#### **URGENT FIELD SAFETY NOTICE**

Tibial Components / Modular Joint Component Units of Endo-Model – M Modular Knee Prosthesis System

Tibial Components of Endo-Model SL Rotational and Hinge Knee Prosthesis System

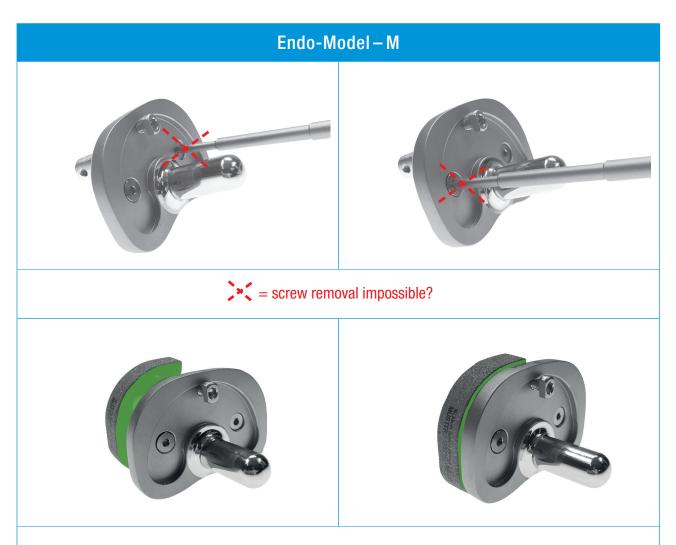
If a Tilastan proximal spacer is to be used and either one or both blind screws of the modular tibial component cannot be loosened, then the following modified surgical technique is to be performed.

It has to be observed that a homogenous cement mantle between the Tilastan proximal spacer (full & half) and modular tibial component is ensured. The cement mantle should be 1-2 mm thick.
